GE Hitachi Nuclear Energy

Docket No. 52-010

Subject: **Response to NRC Request for Additional Information Letter No. 365
Related to ESBWR Design Certification Application – Fuel Storage
and Handling - RAI Number 9.1-15 S04**

RAI Number 9.1-15 S04

Figure 1. Liner Cover Plate Configuration

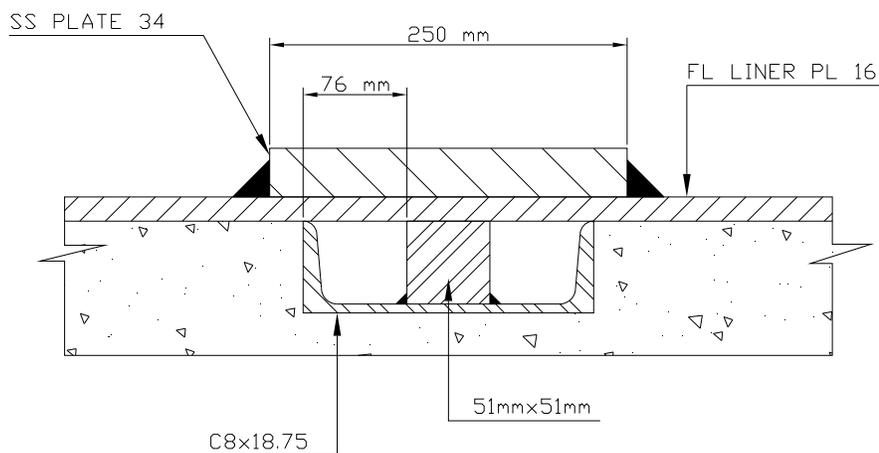
The staff reviewed GEH response to RAI 9.1-15, S02, received via GEH letter MFN 08-424 dated April 29, 2008. The staff generally agrees with the methodology used by GEH for evaluation of the liner plate against impact of a dropped fuel assembly. However, to determine adequacy of the alternative analysis, and to complete its review, the staff requests GEH to provide the following additional information:

- 1. The original analysis calculated required thickness of the liner plate considering local effect on the liner plate due to impact of a dropped fuel assembly using the empirical formula (BRL formula) in Bechtel Topical Report BC-TOP-9A (local damage prediction). Provide a description of the alternative analysis including assumptions used, analysis results, and acceptance criteria used, and explain how results of the alternative analysis compare with those of the original analysis.*
- 2. Describe evaluation of structural response of the liner plate due to impact of a dropped fuel assembly (overall damage prediction) including assumptions used, analysis results, and acceptance criteria used. Otherwise, provide justification why overall damage prediction for the liner plate due to impact of a fuel assembly need not be performed.*

The calculated T value is 1.57 inch (40 mm). It is increased by 25% to result in 1.97 inch (50 mm) to prevent perforation in accordance with Reference 2.

To meet the thickness requirement, a cover plate of 1.34 inch (34 mm) thickness is added to the top of the 0.63 inch (16 mm) thick liner plate over the leak chase channel as shown in Figure 1. The cover plate is made of the same material as the liner. Its width is 9.84 inch (250 mm) and the length is sufficient to cover the total length of the leak chase channels. The cover plates are installed above the liner welds that are not covered by the spent fuel racks.
